TECHNICAL SERVICE BULLETIN

26-2136

No Start, LH Headlamp Fogging And Heated Systems Always On Due To Water Ingress At Ground Connection G110 - DTCs B1D00-15, B1097-14, B147C-14, B1C83-14

Ford 2024-2025 Transit	Assembly Plant: KOCAELI PLANT BUILD (AAGBX) Built on 06-May-2024 and through 18-Mar-2025
----------------------------------	---

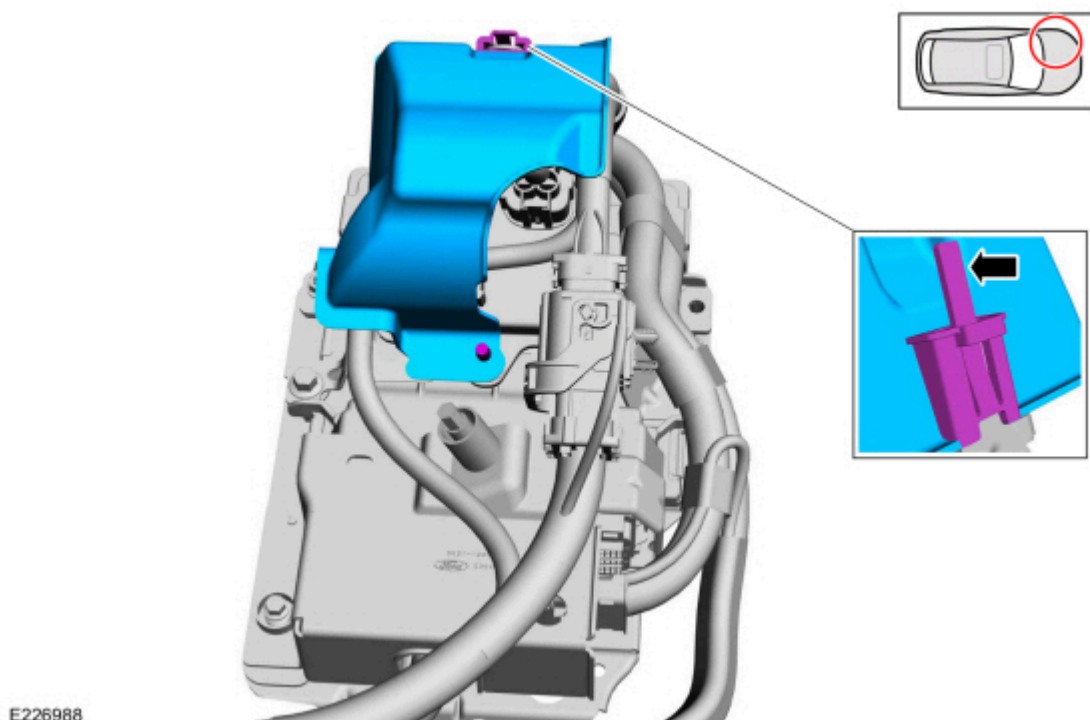
1. Remove the left-hand side headlamp assembly. For additional information, refer to 2024 Transit Workshop Manual Section 417-01.
2. Check the headlamp electrical connector **C1021**.
 - (1). If moisture / corrosion is observed inside the electrical connector, clean / repair as required. For detailed information refer to the corresponding Workshop Manual Section under the Wiring tab in the PTS.
 - Connect the cleaned / repaired connector.
 - Go to next step.

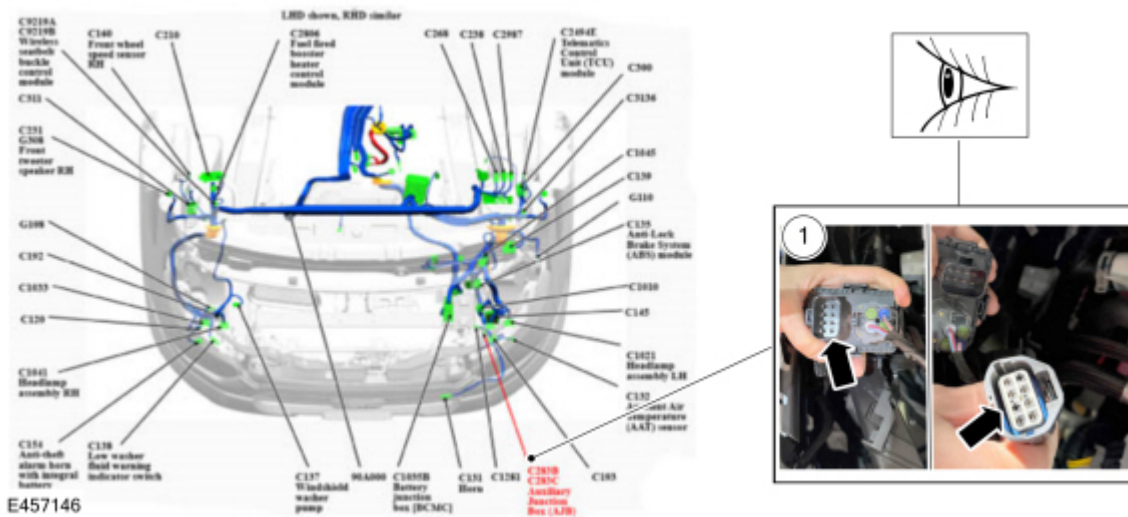
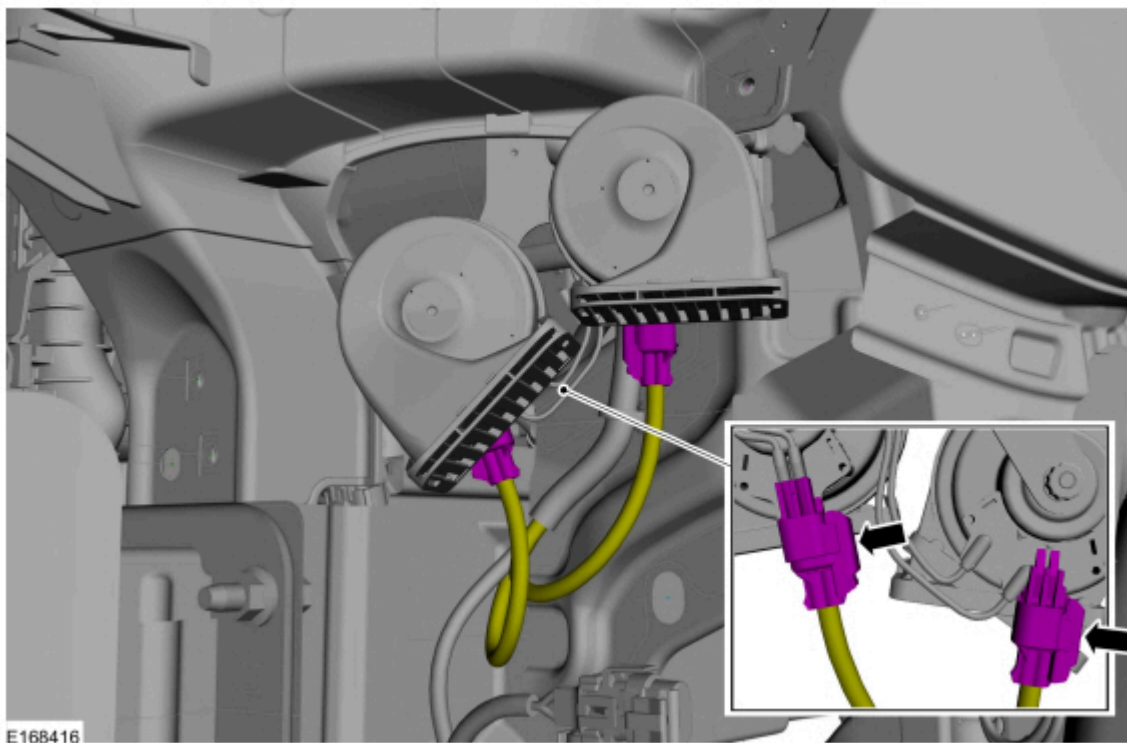
4. Check the AJB electrical connector **C283B** and **C283C**.

(1). If moisture / corrosion is observed inside the electrical connector, clean / repair as required. For detailed information refer to the corresponding Workshop Manual Section under the Wiring tab in the PTS.

E457147

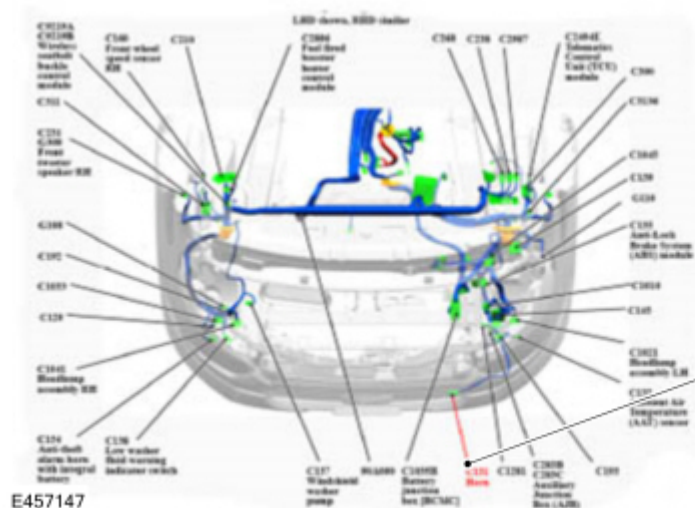
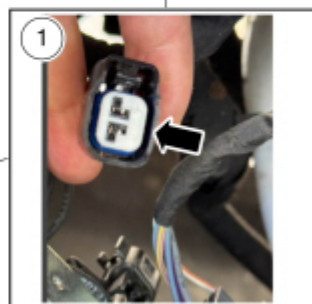
6. Check the horn electrical connectors **C131**.

(1). If moisture / corrosion is observed inside the electrical connectors, clean / repair as required. 'For detailed information refer to the corresponding Workshop Manual Section under the Wiring tab in the PTS.

Ground connection G110 - Rework

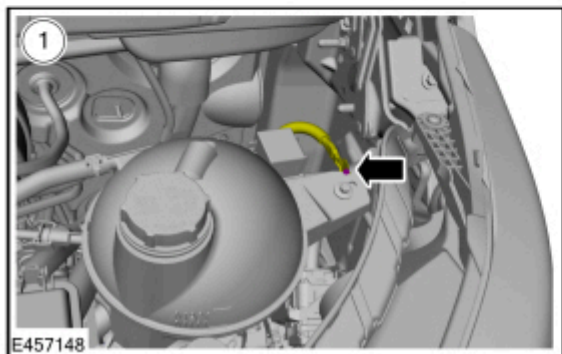
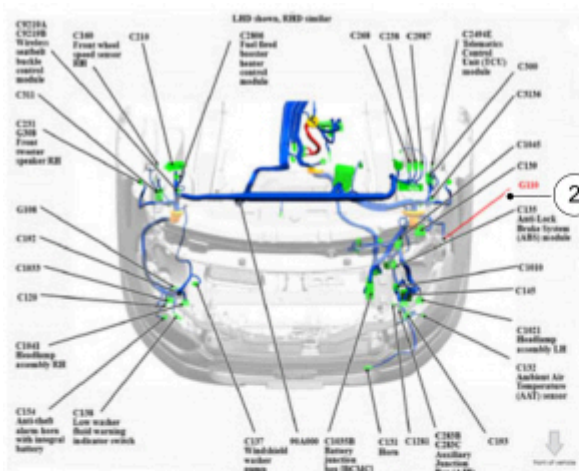
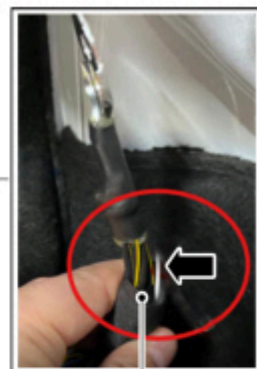
1. Apply sealant and PVC tape to insufficiently protected individual wires of the ground connection **G110** (see Parts Required).

(1). Locate the ground connection (eyelet) **G110** in the left-hand side of the engine compartment and unscrew the bolt. Torque: 10.5 Nm

(2). Locate the area of insufficiently protected individual wires.

(3). Apply the sealant by starting at the back of the eyelet. Sealant should be applied on all insufficiently protected wires.

- Allow the sealant to dry.
- Apply the PVC tape above the sealant and make sure all insufficiently protected wires are fully taped.
